**STATE OF HAWAII
DEPARTMENT OF TRANSPORTATION
HARBORS**

**ADDENDUM NO. 1
FOR
HONOLULU HARBOR, PIERS 51-53, FENDER REPAIRS
OAHU, HAWAII
JOB S10954**

June 8, 2026

STRUCTURAL NOTES:

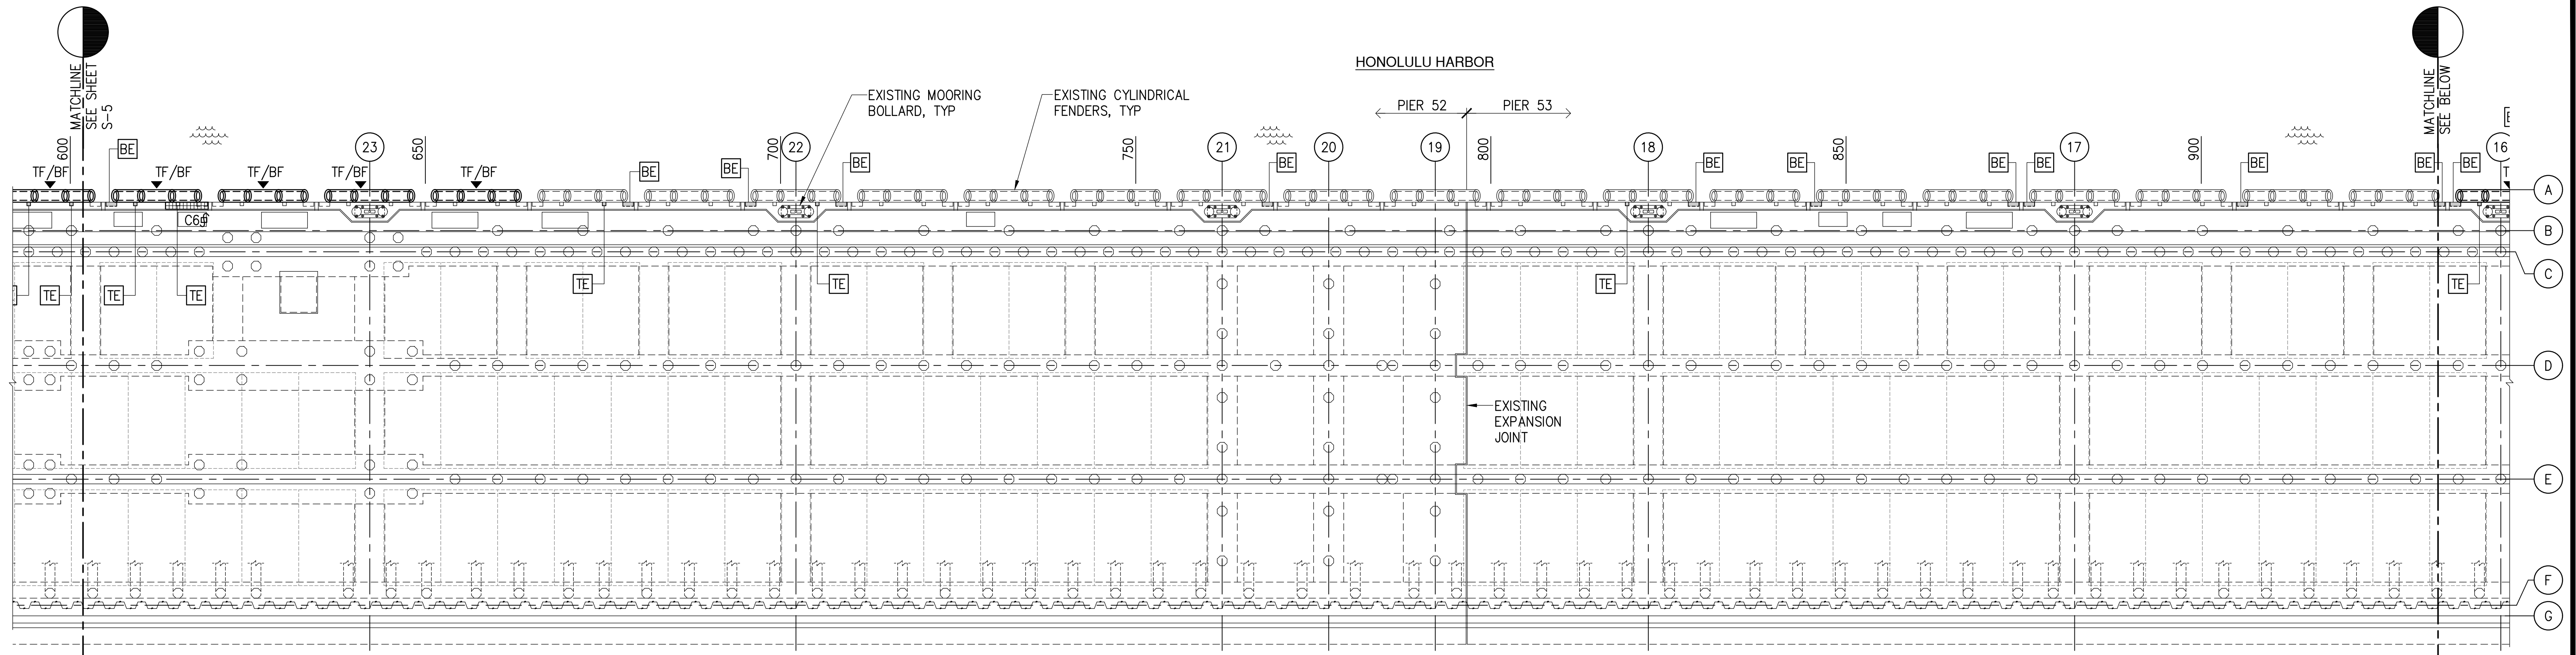
2. On sheet S-1, note 1 of the Reinforcing Steel section calls for duplex stainless-steel bars. Spec section 15.2.C notes the reinforcing steel as ASTM A706, grade 60. Please advise what material the replacement reinforcing steel shall be.

1. REINFORCING STEEL SHALL BE DEFORMED BARS CONFORMING TO ASTM A706, GRADE 60.

See Addendum No. 1.

PARTIAL PIER 52-53 PLAN

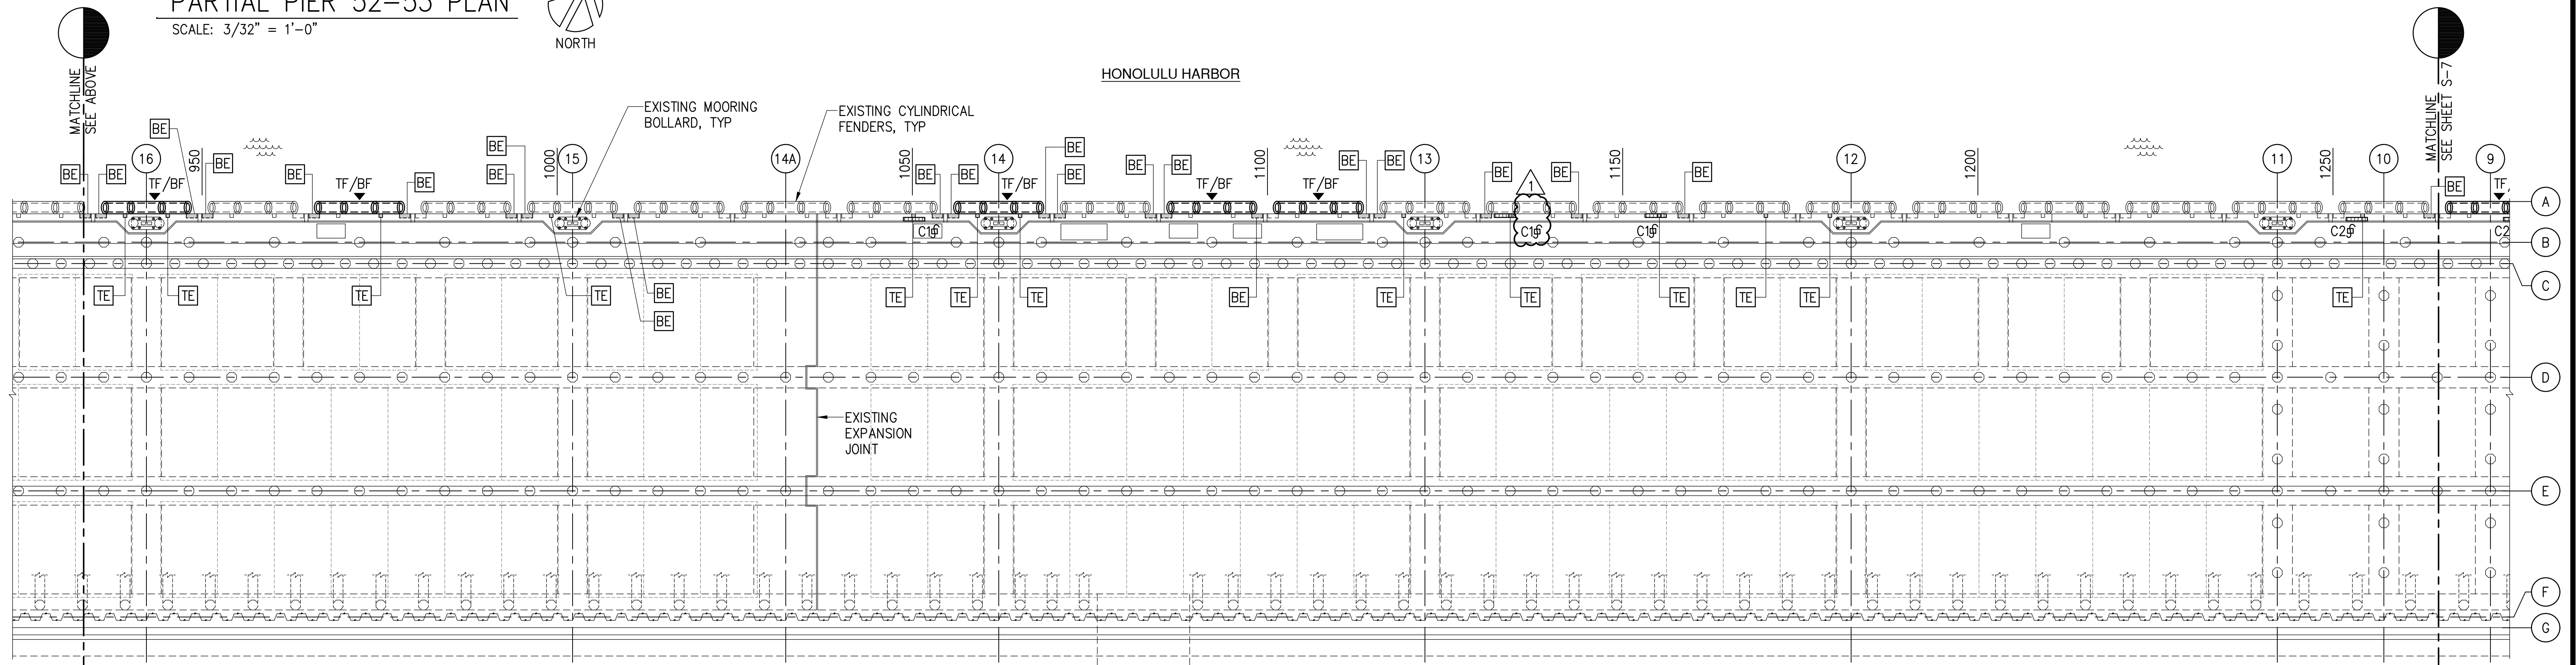
5. It appears there is a spall located between Bent 13 and DM 1150 on sheet S-6. Please advise if this is a curb (C) or vertical (V) spall repair.

See Addendum No. 1.

PLAN

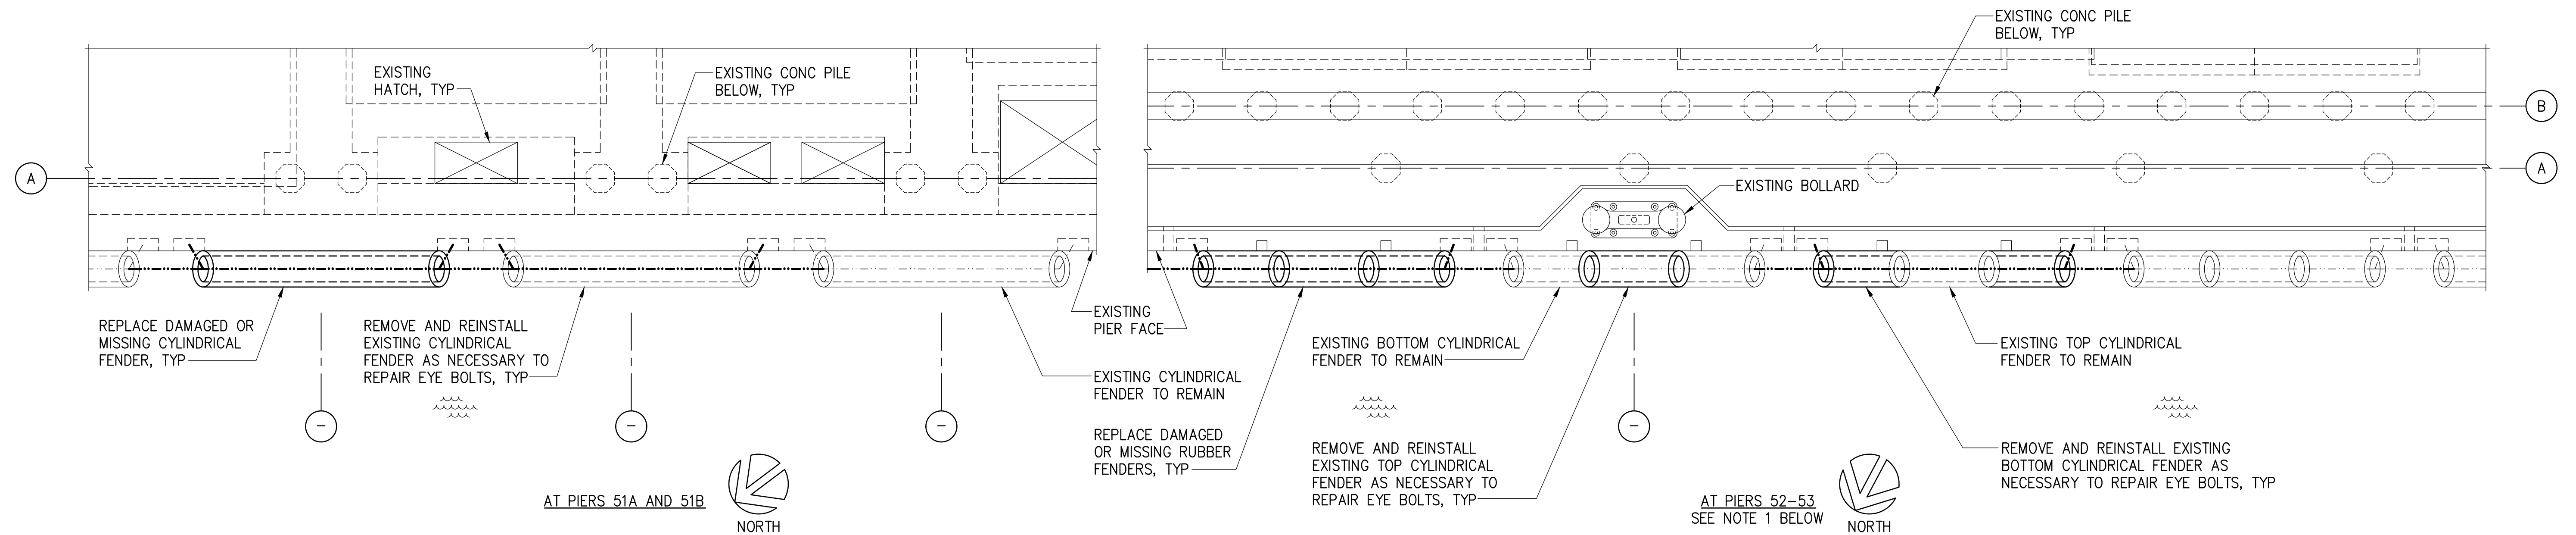
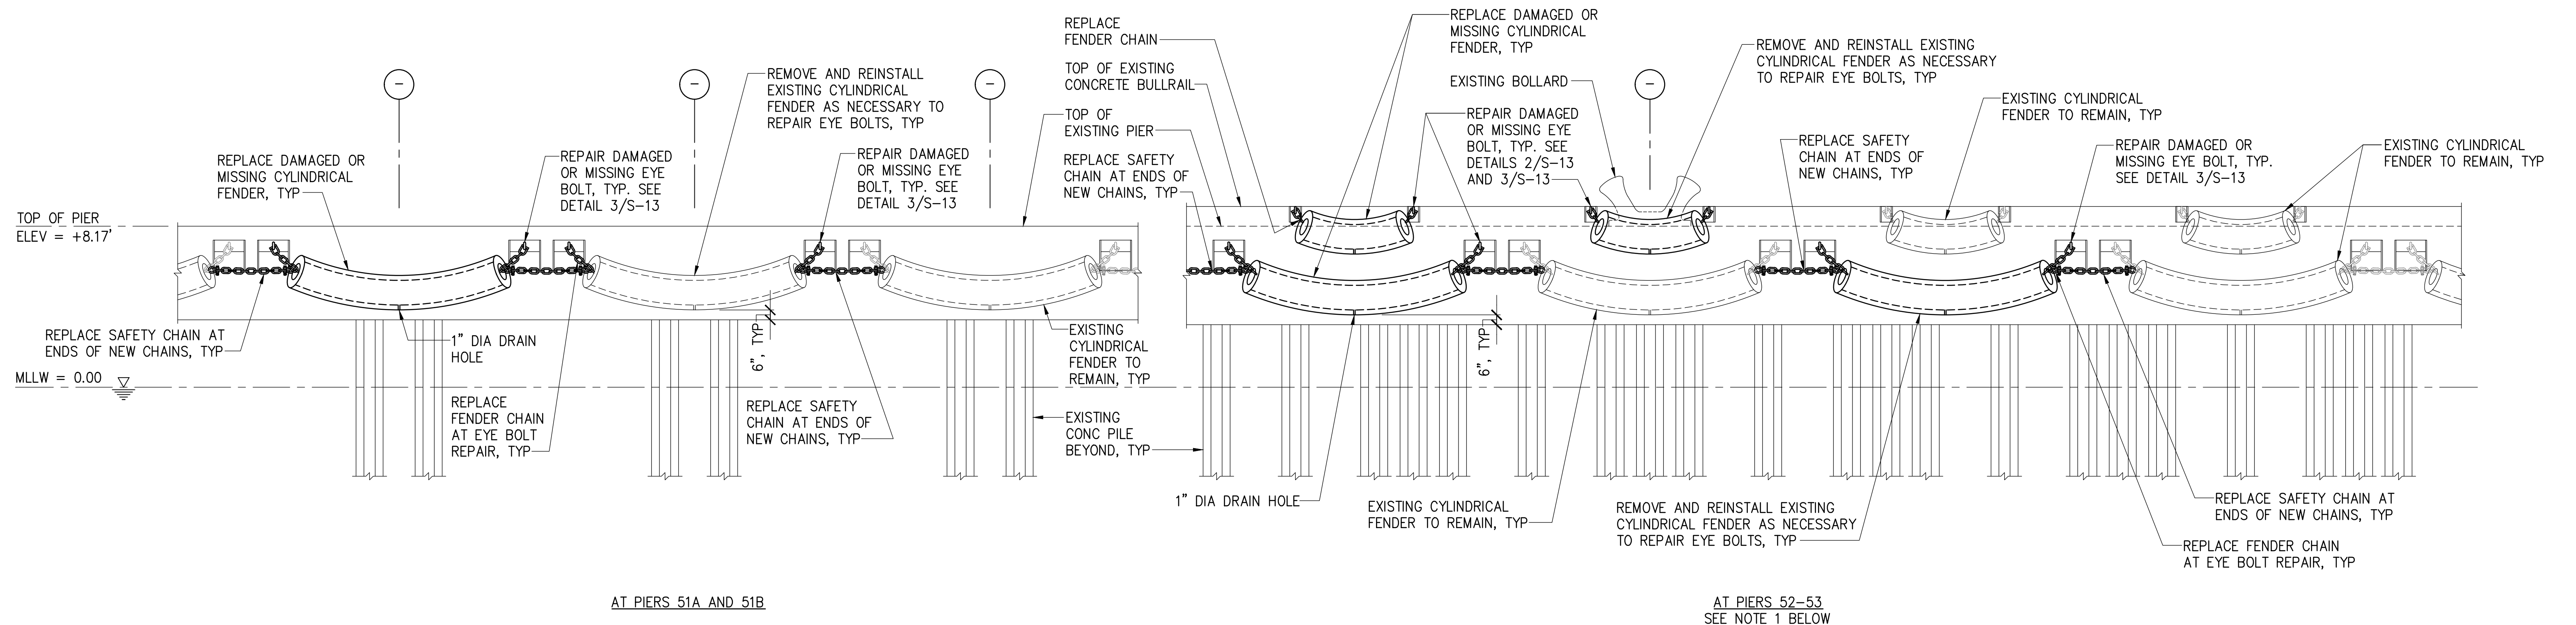
11. Please provide size of drain holes.

The size of the drain holes is provided on Sheet S-12

2 TOP EYE BOLT REPAIR DETAIL
S-13 SCALE: 1'-1/2" = 1'-0"

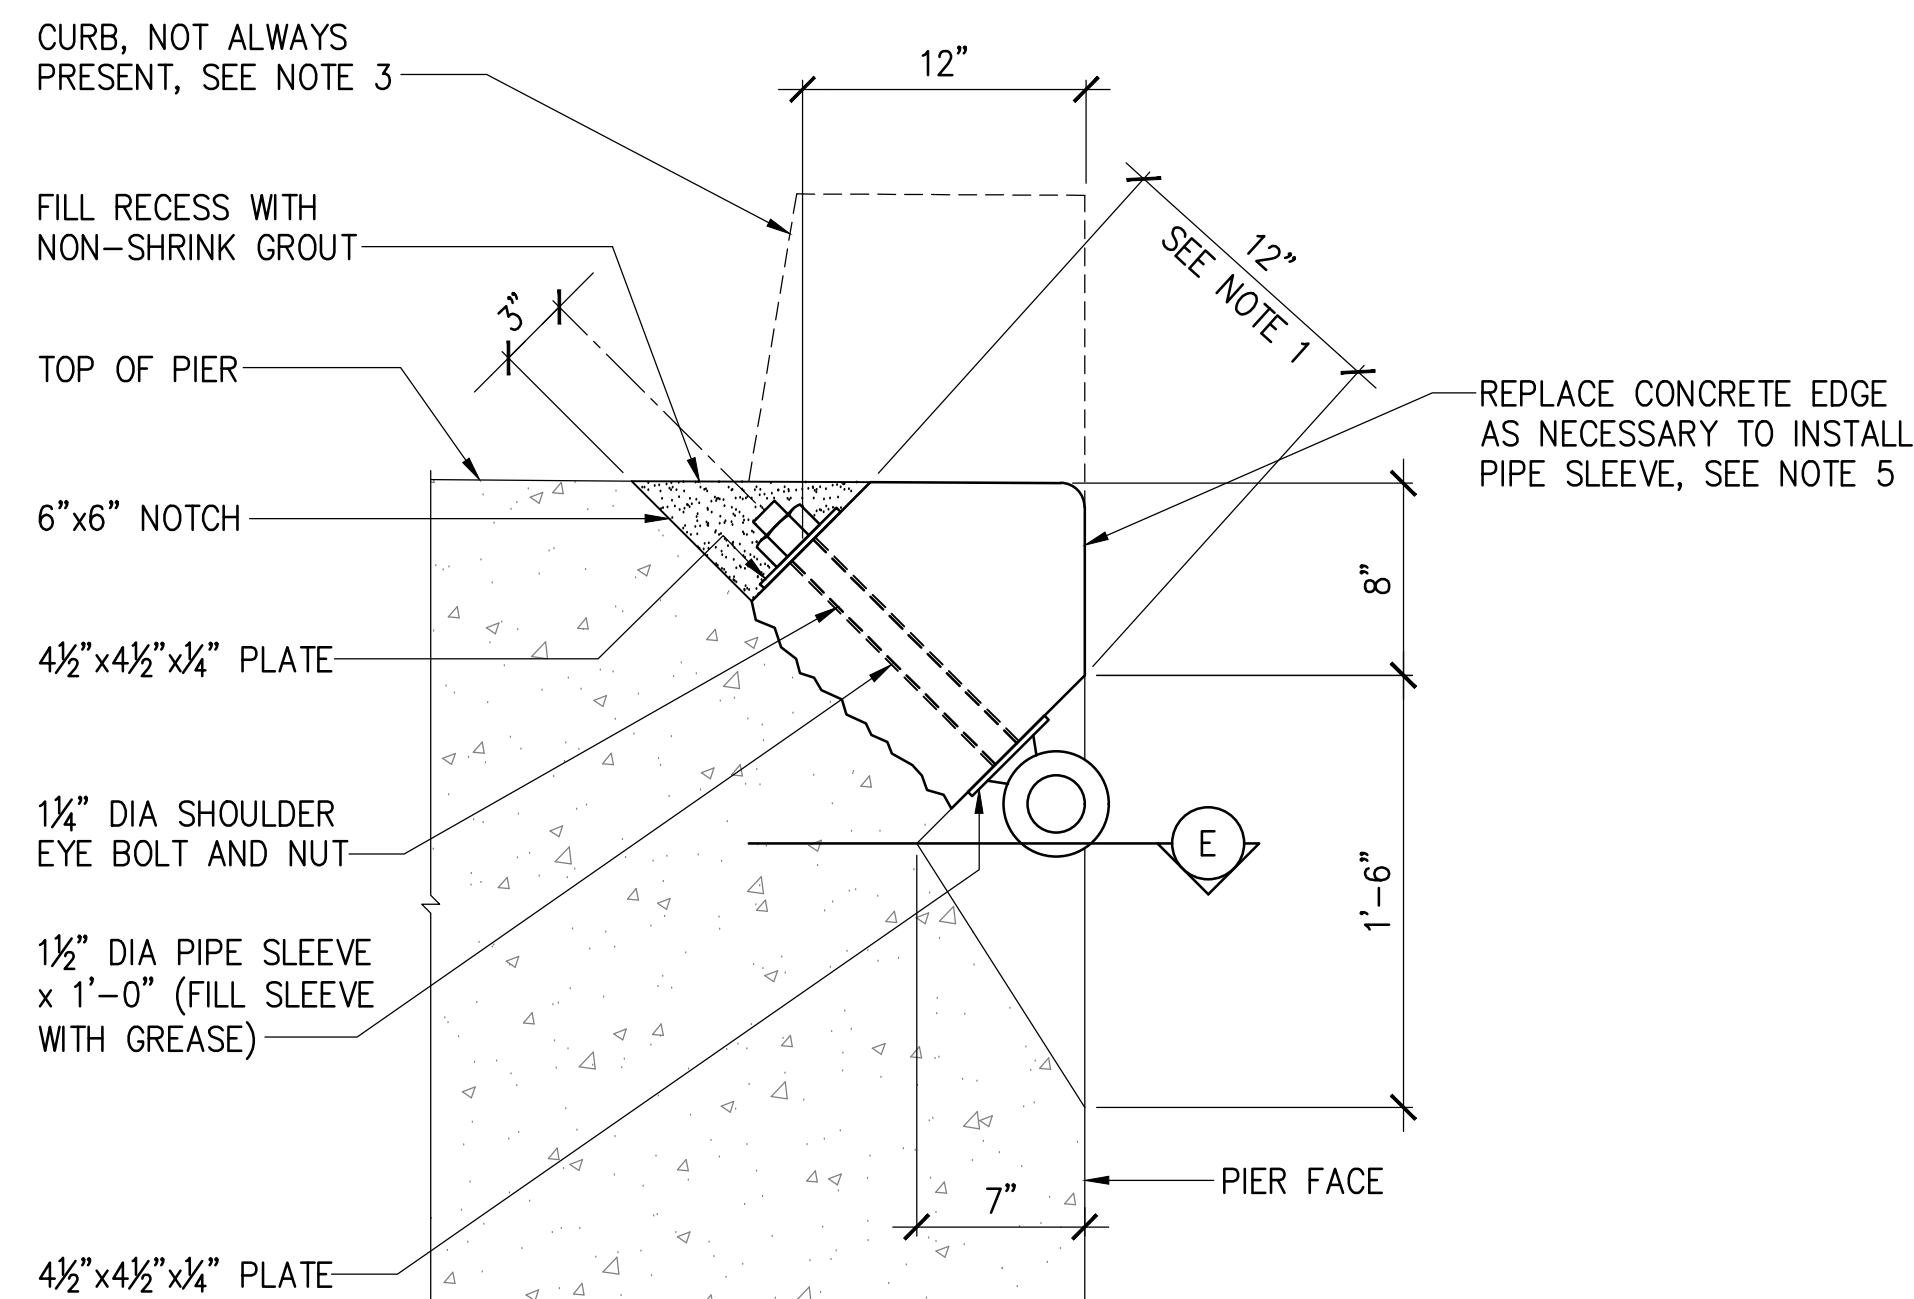
7. Note 5 in detail 3/S-13 states spalls at the eye bolt blockout shall be paid per detail S/S-12. However, detail 2/S-12 is not provided in the drawings. Please clarify how the eye bolt spalls shall be repaired and paid for. a. See next two questions

1. CONDITION AT PIER 51A AND 51B SHOWN.
2. PIPE SLEEVE LENGTH IS 11" AT PIERS 52 AND 53.
3. CONCRETE CURB IS PRESENT AT PIERS 52 AND 53.
4. EYEBOLT AND ALL HARDWARE SHALL BE HOT-DIPPED GALVANIZED AFTER FABRICATION.
5. CONCRETE SPALLS AT EYE BOLT BLOCKOUT SHALL BE PAID FOR AND REPAIRED PER DETAIL 2/S-14.
6. CONCRETE EDGE SHALL BE REPLACED AS NECESSARY TO INSTALL EYE BOLT ASSEMBLY. A LENGTH OF 1'-0" SHALL BE INCLUDED IN THE PAYMENT ITEM FOR EACH BOTTOM EYE BOLT REPAIR.

See Addendum No. 1.
